Addendum No: One (1)

Project: Washington Marion High School – Athletic Facilities

Architect's Project No: HL-058-03

Date: May 19, 2021

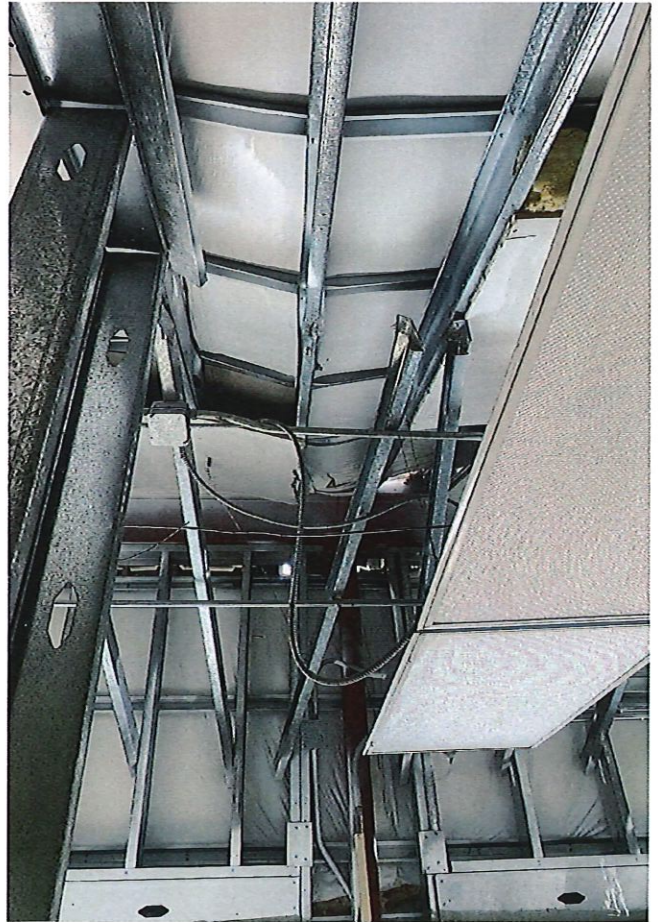
- 4) **SHT A2.2 – West Elevation:**
Contractor shall remove existing sign and provide a new 4' x 12' lighted sign cabinet to match existing that says "Robert LaVergne JR. Memorial Stadium" Colors and layout of sign will be verified during shop drawing phase. (See attached photo of existing sign)

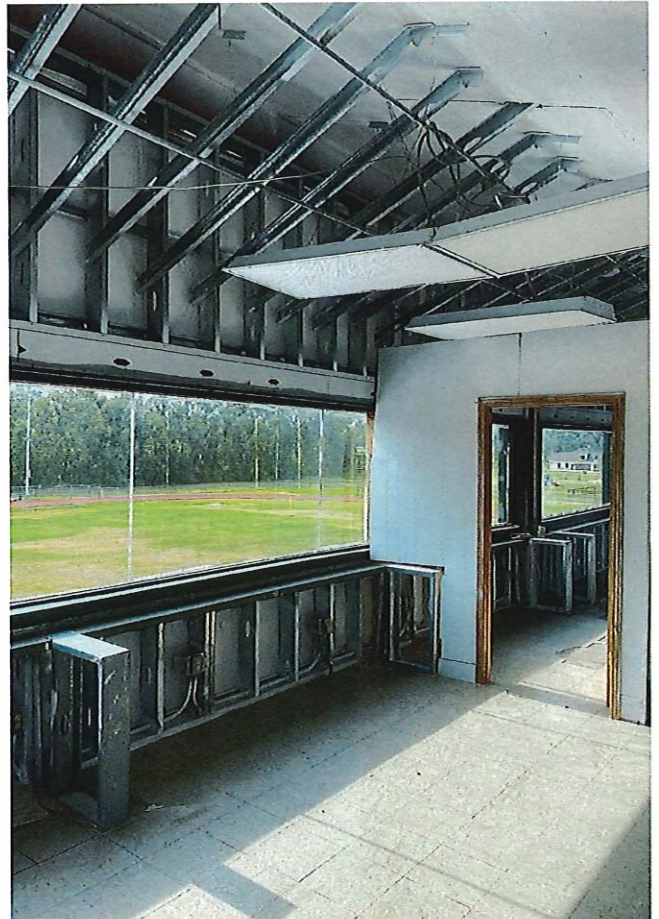
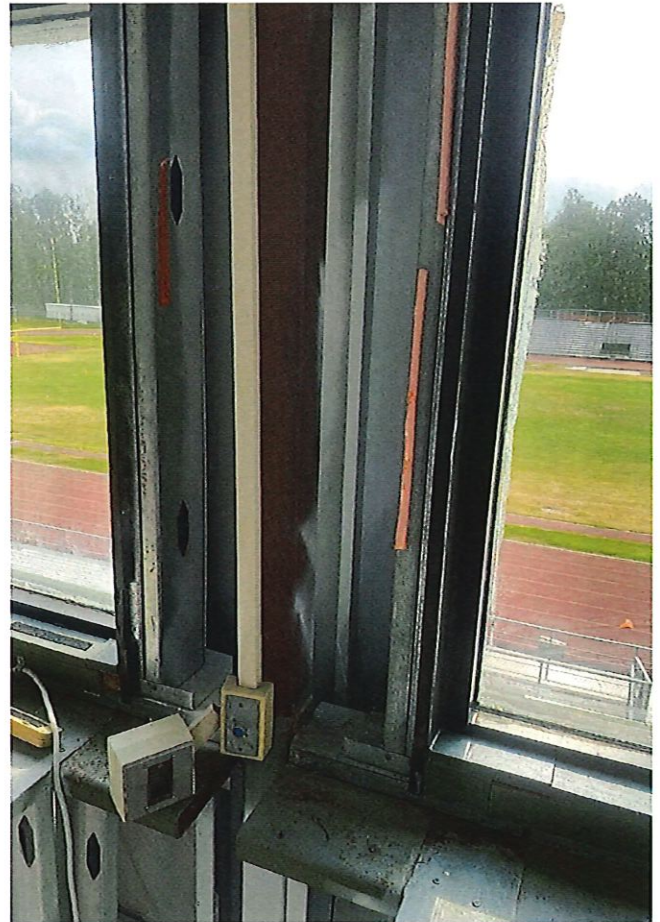
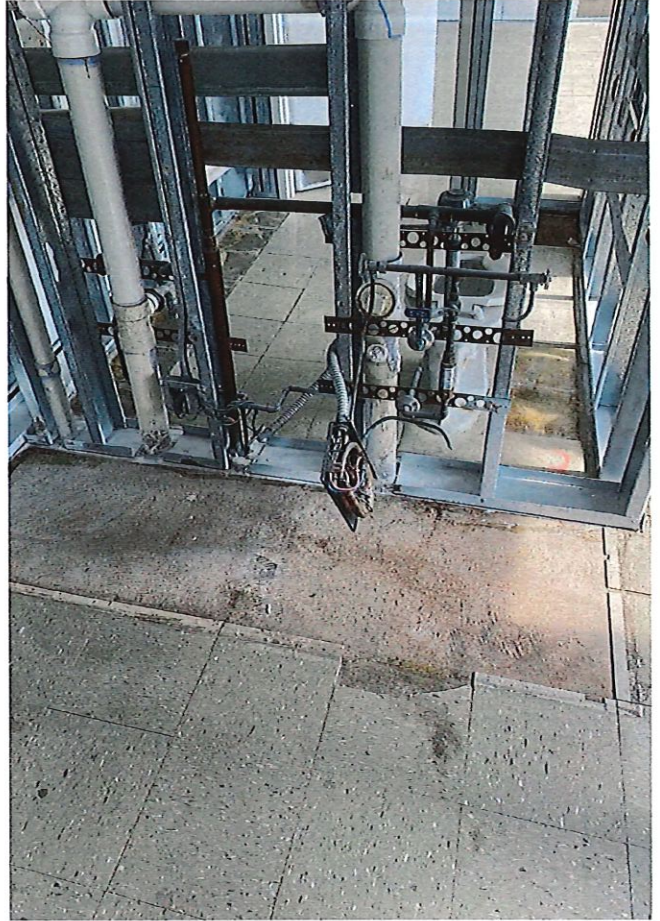
Notes 1, 2, 3 : All items listed to be demolished or removed inside of press box have already been removed excluding some gypsum board, floor tiles, and lights. (See attached photos of press box interior from May 16). Contractor to verify

MP
1.2R
SHEET

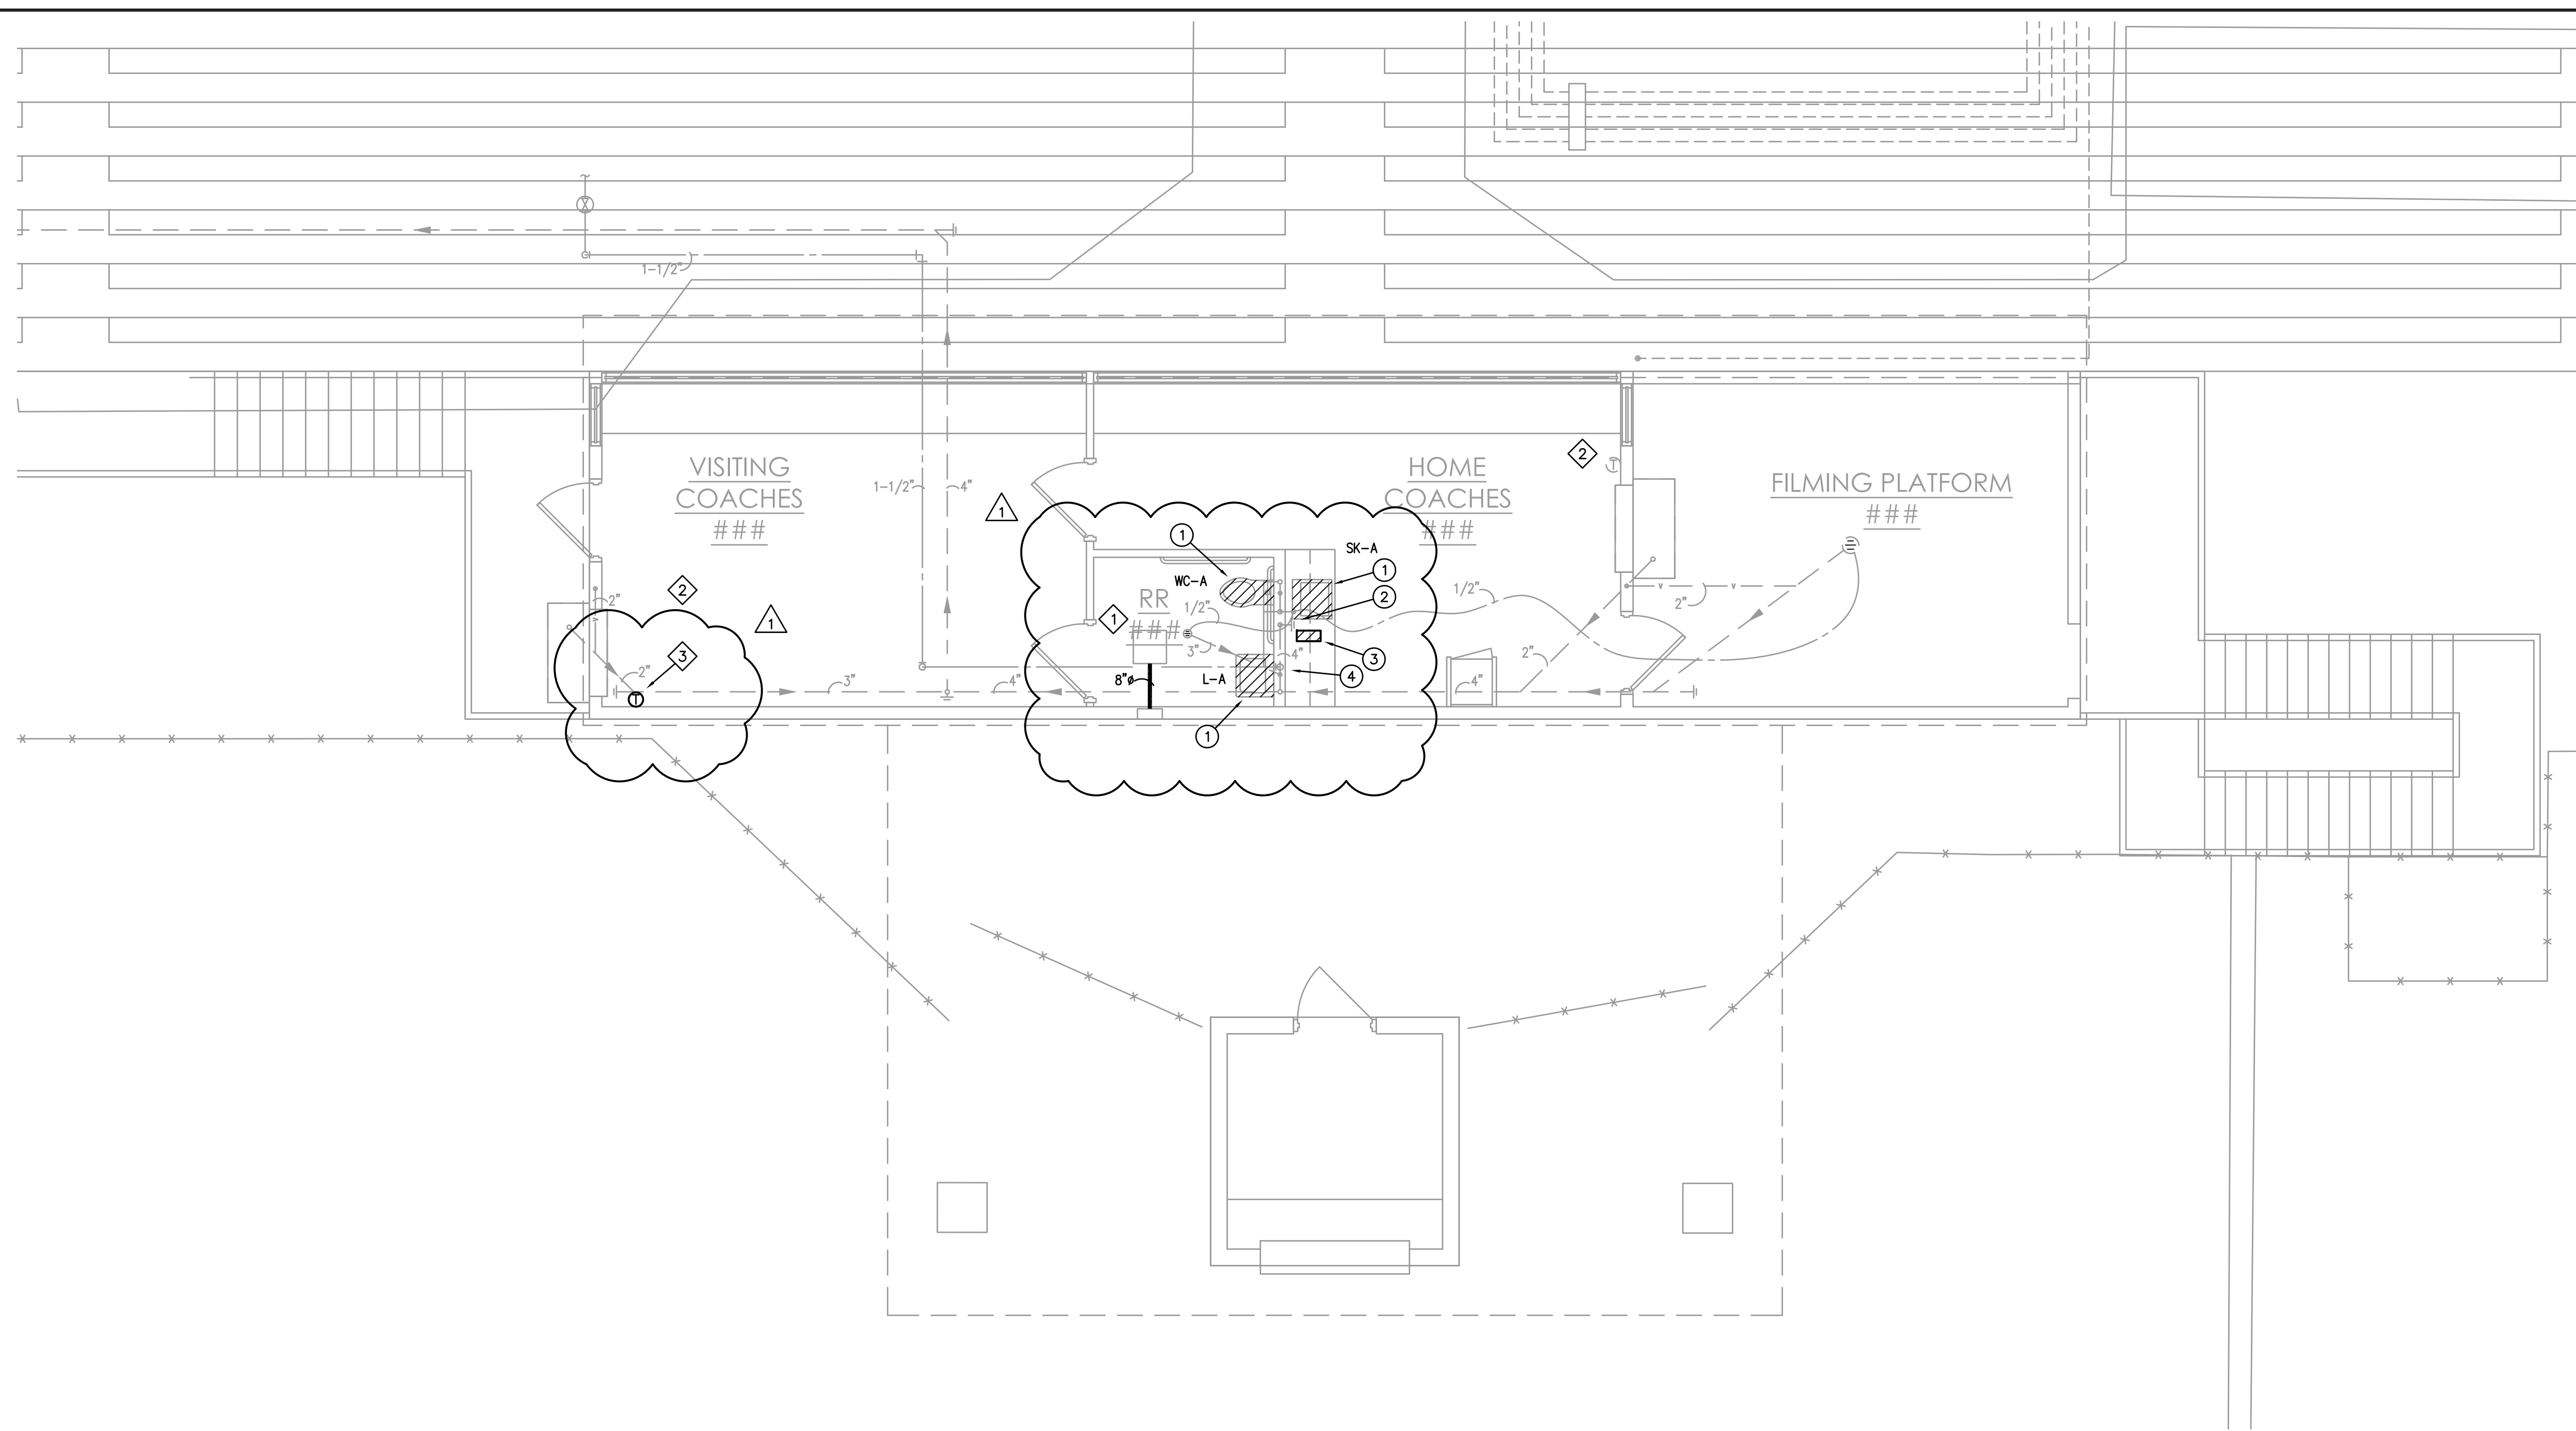
- 7) Ref attached revised SHT M1.2R:
 - a. Provide new plumbing fixtures as scheduled and keynoted.
 - b. Provide new water heater as keynoted.
 - c. Extend new 1/2" hot water pipe in wall to serve new lavatory as keynoted.
 - d. Provide insulation on all existing domestic hot and cold-water piping per specifications as keynoted.
 - e. Provide new thermostat at North Bard unit as keynoted.
 - f. Install existing exhaust fan in new ceiling grid and resecure to structure as keynoted.

- 1 EXISTING EXHAUST FAN TO REMAIN. RESECURE FAN TO DECK AND INSTALL IN NEW CEILING. COORDINATE WITH NEW CEILING TILE SUCH THAT FAN IS INSTALLED IN CENTER OF GRID. PROVIDE NEW EXHAUST DUCT AT EXISTING SIZE (APPROX. 8") TO EXTERIOR WALL AND CONNECT TO WALL OUTLET. SEAL WALL PENETRATION AIR TIGHT. COORDINATE EXACT WALL OUTLET LOCATION AND DUCT SIZE IN THE FIELD.
- 2 REMOVE AND REINSTALL EXISTING BARD SUPPLY AND RETURN GRILLE AND THERMOSTAT AS REQUIRED TO COMPLETE ARCHITECT'S SCOPE OF WORK. PROVIDE NEW THERMOSTAT COVER. COORDINATE THERMOSTAT COVER STYLE WITH ARCHITECT PRIOR TO SHOP DRAWING PHASE.
- 3 PROVIDE NEW THERMOSTAT TO REPLACE EXISTING DAMAGED. PROVIDE NEW THERMOSTAT COVER AS NOTED IN KEYNOTE #2.

- 1 REMOVE EXISTING PLUMBING FIXTURES AND PROVIDE NEW AS SCHEDULED. CONNECT TO EXISTING DOMESTIC WATER AND SEWER SERVICES. EXTEND NEW 1/2" DOMESTIC HOT WATER CONNECTION FROM WATER HEATER TO LAVATORY IN WALL.
- 2 EXISTING WALL CLEANOUT TO REMAIN AND BE ACCESSIBLE THROUGH NEW MILLWORK. COORDINATE WITH GENERAL CONTRACTOR.
- 3 REMOVE EXISTING WATER HEATER AND PROVIDE NEW EEMAX SFXE48 OR APPROVED EQUAL 4.8KW, 240-1-60 ELECTRICAL SERVICE, 0.25 LOW ACTIVATION FLOW TANKLESS WATER HEATER MOUNTED UNDER SINK IN MILLWORK. EXTEND EXISTING DOMESTIC COLD PIPING WITH CUTOFF VALVE AND CONNECT TO WATER HEATER. CONTINUE WITH 1/2" DOMESTIC HOT WATER PIPING IN WALL TO SINK AND LAVATORY. COORDINATE WITH ELECTRICAL CONTRACTOR.
- 4 INSULATE ALL EXISTING DOMESTIC HOT AND COLD WATER PIPING IN PRESS-BOX AS NOTED IN SPECIFICATIONS.
